ECE/TRANS/WP.29/GRPE/2009/7  
31 October 2008

##### Regulation No. 83

##### Proposal for draft amendments to Regulation No. 83

Submitted by the expert from Germany<sup>1</sup>

**Figure 8/2:** Parameters measured during emissions test during and between cycles where regeneration occurs (schematic example)

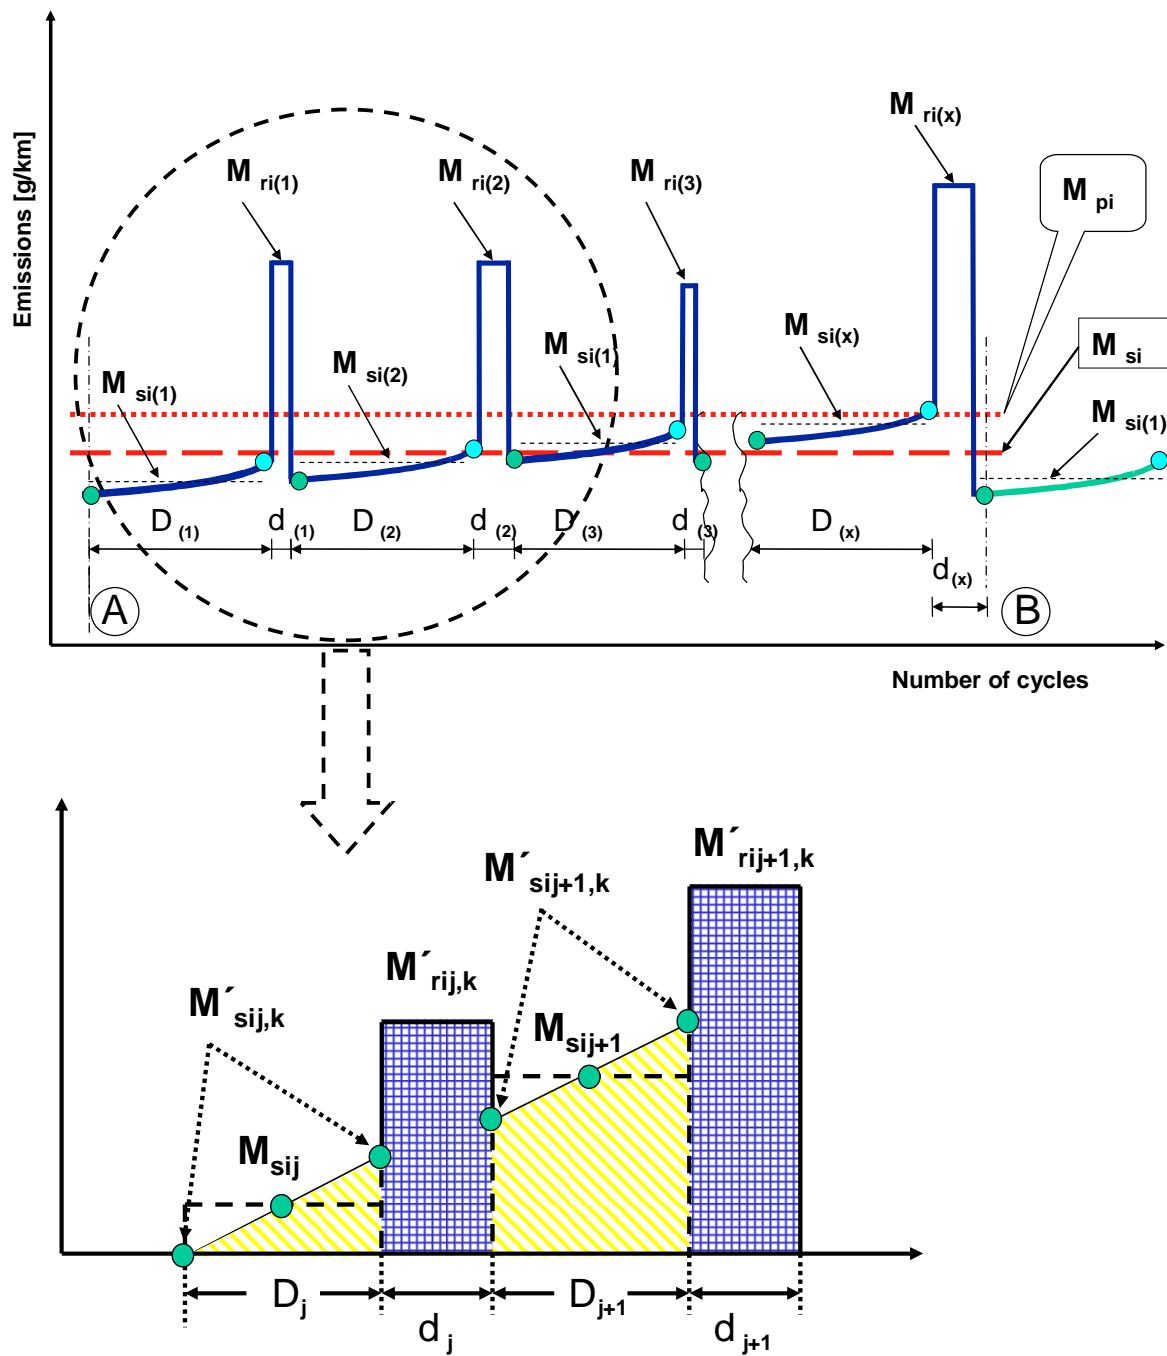
**3.4. Calculation of combined exhaust emissions of multiple periodic regenerating systems**

For exemplary illustration of measurement parameters see Figure 8/2.

The calculation of the factor ( $K_i$ ) for multiple periodic regenerating systems is only possible after a certain number of regeneration phases for each system. After performing the complete procedure (A to B, see Figure 8/2), the original starting conditions A should be reached again.
